PRODUCT ADVISORY

Data Sheet Specification Change for Intersil Products ISL78600ANZ and ISL78600ANZ-T

**Refer to:
PA13004**

Date: January 11, 2013

FIGURE 44. TYPICAL APPLICATIONS CIRCUIT - BATTERY CONNECTION CIRCUITS

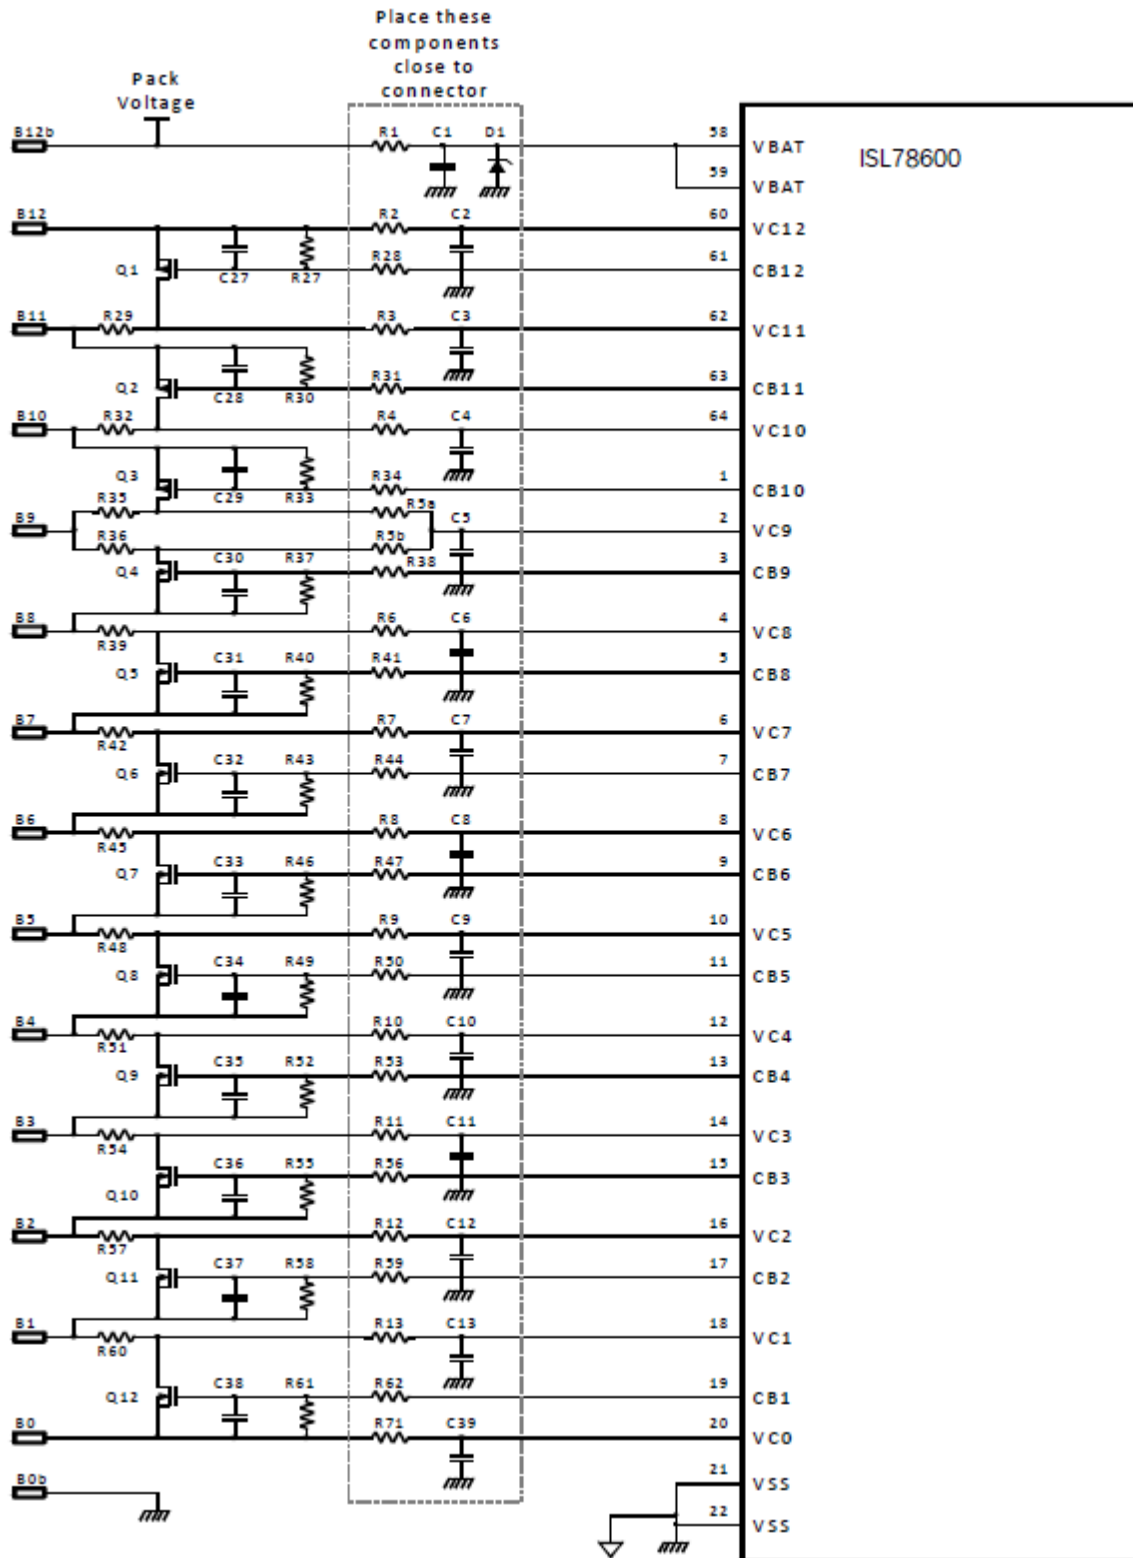
This advisory is to inform you that Intersil has updated the data sheet specification for the ISL78600ANZ and ISL78600ANZ-T products. The updates affect the *Typical Applications Circuits (Figures 45–47)* along with the associated recommended component values in *Table 50* and the component values in *Table 52* for the Daisy Chain Circuit. The resulting Typical Applications Circuits and component tables are included on the following pages. The updated data sheet is available upon request.
